FHWA REG NO.	STATE	PROJECT NO.	YEAR	SHEET NO.	TOTAL SHEETS
7	KANSAS	STP-N012(901)	1999	42	131

KANSAS DEPARTMENT OF TRANSPORTATION
448-89404
PAWNEE AVENUE
E. of Rock to WEBB
WATER LINE RELOCATION

PLAN - MAIN 4
SCALE: 1 : 500

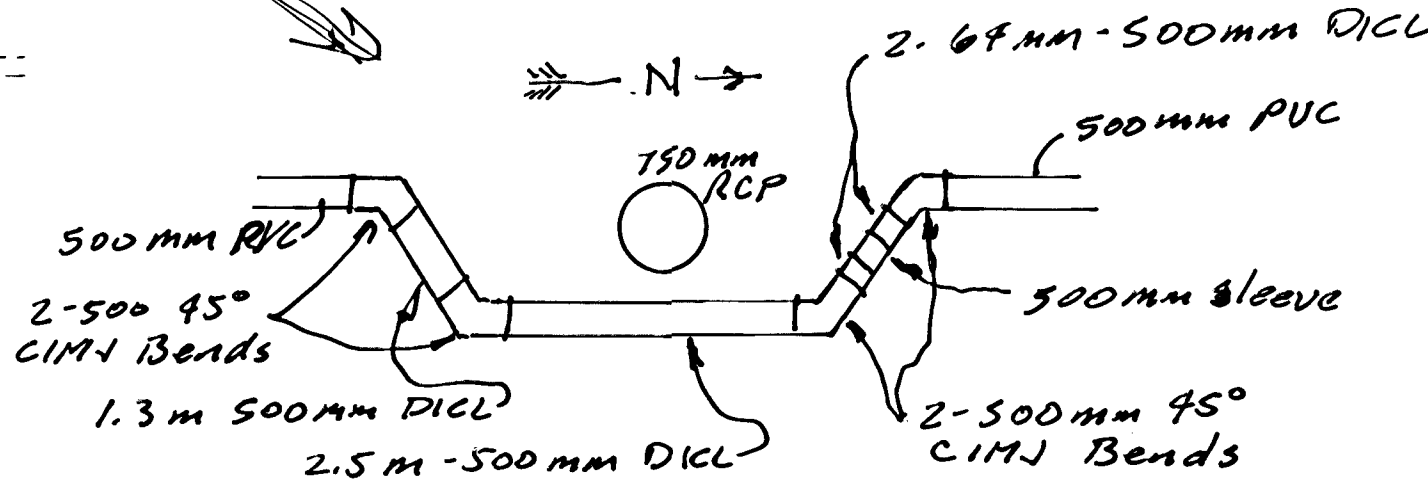
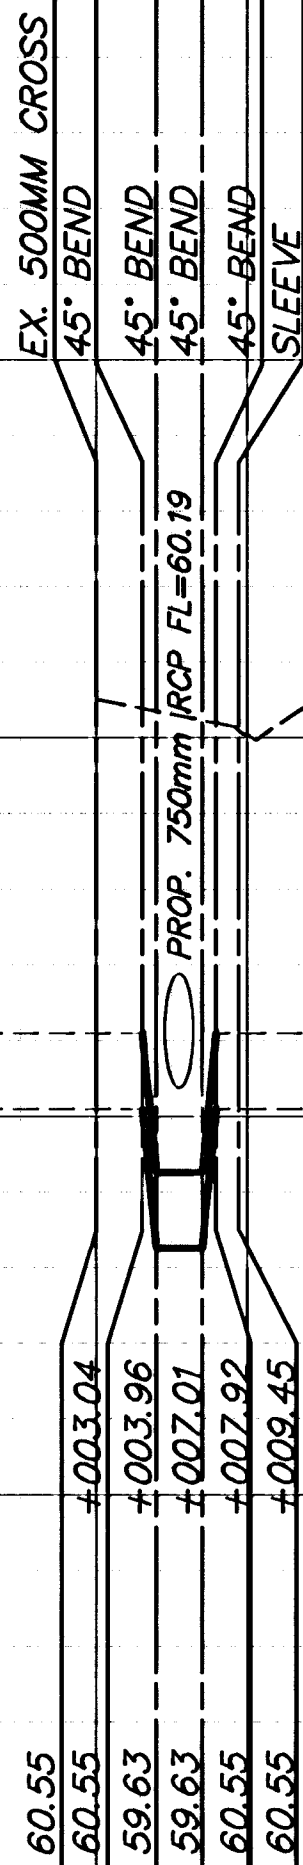
Added Waterline Correction
@ Sta. 4+723.57, 14.0'm Rt
(to accomodate SWS Revision)
